SHOCK ABSORBER AND FRONT SHOCK MOUNT

The purpose of this bulletin is to announce the release of a **new** shock absorber kit for all 1995-2000 S1, S1W, M2, S2/S2T, S3/S3T, and X1 Model Buell motorcycles and to provide installation and adjustment instructions. Buell Motorcycle Company has developed this kit as an upgrade to the shock absorbers currently in use.

Figure 2. New Shock Absorber Assembly

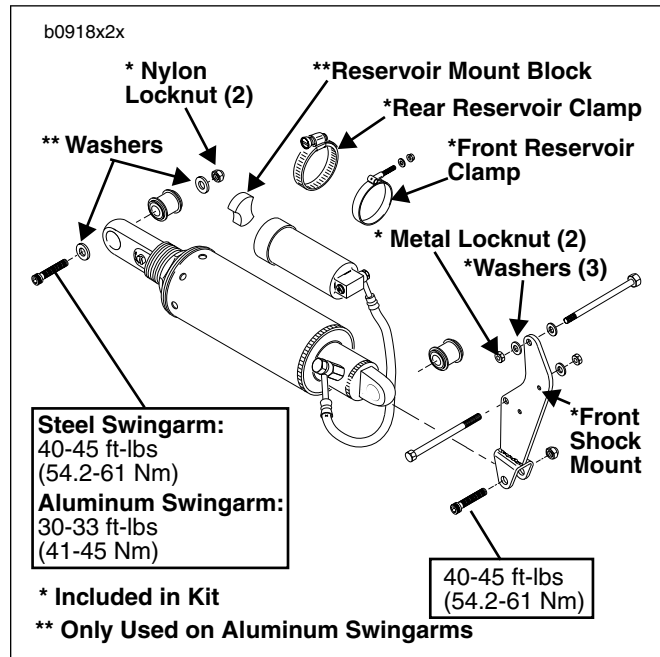
The new front shock mount **MUST** be used with the new shock absorber. The new shock is 1.77 in. (45 mm) shorter than the previous shocks and requires the new front mount to align and install properly.

1. See Figure 2. Install **new** front shock mount to crankcase with two **new** front shock mount bolts, washers, star washer (on 1997 M2, S3/S3T models only) and metal locknuts. Tighten bolts to 30-33 ft-lbs (41-45 Nm). NOTE: Top bolt goes in from the left side, bottom bolt goes in from right side. Bottom bolt does not use washer under bolt head. Star washer (only used on 1997 M2, S3/S3T models) goes on bottom bolt under the washer on the nut side. If exhaust was loosened during front shock mount removal, replace exhaust gaskets and reinstall exhaust. See appropriate Service Manual, Section 2 for instructions.
2. **All Models Except S1/ S1W/S2/S2T:** Apply LOCTITE THREADLOCKER 243 (Blue) to threads of **new** button head fastener. Fasten voltage regulator bracket to front shock mount with **new** small button head fastener. Tighten fastener to 5-6 ft-lbs (7-8 Nm).

4. See Figure 2. Position **new** shock absorber from kit in mounting position.
5. Loosely install bolt, washers (aluminum swingarms only) and **new** locknut through rear shock eye and swing arm.

Figure 3. Reservoir Clamps (X1 Model Shown)

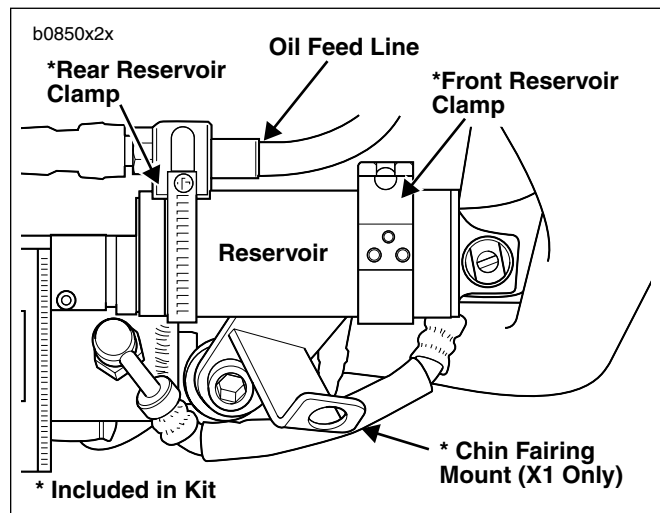
10. See Figure 3. Loosely install **new** rear clamp around reservoir and oil feed line.
11. **All Models:** Install **new** reservoir mount block between oil pump fitting and remote reservoir.

Figure 4. Measuring Preload

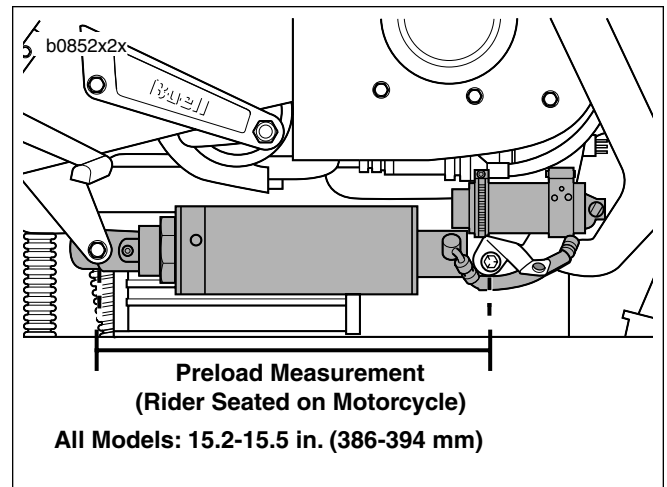
1. See Figure 4. Check and adjust rear shock preload.
 - a. With rider seated on motorcycle, the preload is determined by measuring the distance between the centers of the front and rear shock eye and adjusting until the measurement is within specification.
 - b. See below for optimum preload measurements:
 - **All Models:** 15.2-15.5 in. (386-394 mm)
- *Riders with passenger at or near GVWR may exceed optimum preload adjustment.*
2. See Figure 5. To adjust shock preload, loosen the locknut and turn the preload adjuster at the end of the shock to move can towards front or rear of motorcycle. When finished, tighten locknut to 44-58 ft-lbs (59-78 Nm).
 - a. Tighten adjuster (move can towards rear of motorcycle) to **increase** preload.
 - b. Loosen adjuster (move can towards front of motorcycle) to **decrease** preload.

Figure 5. Preload and Compression Damping Adjustment

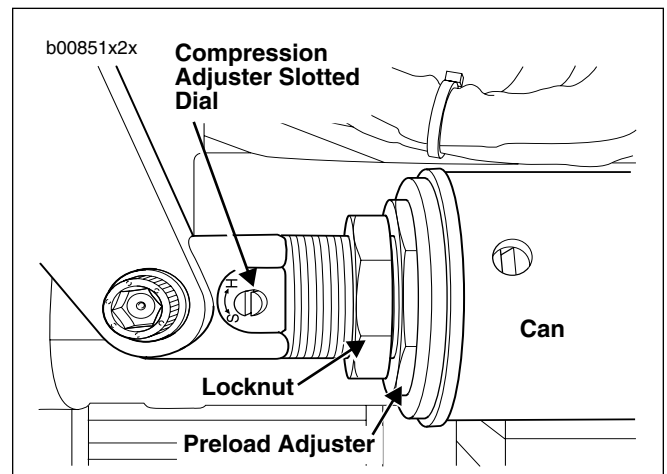
3. See Figure 5. Set compression damping using the slotted dial on the shaft at the rear of the shock. New factory setting is as listed below:
 - **S1/S1W/M2/X1 Models:** full damping minus 2.25 turns.
 - **S2/S2T Models:** full damping minus 2.5 turns.
 - **1997-1998 S3/S3T Models:** full damping minus 2.5 turns.
 - **1999-2000 S3/S3T Models:** full damping minus 2.5 turns.
4. See Figure 6. Set rebound damping using the slotted dial on the remote reservoir at the front of the shock. New factory setting is as listed below:
 - **S1/S1W/M2/X1 Models:** full damping minus 1.5 turns.
 - **S2/S2T Models:** full damping minus 1 turn.
 - **1997-1998 S3/S3T Models:** full damping minus 1 turn.
 - **1999-2000 S3/S3T Models:** full damping minus 1 turn.
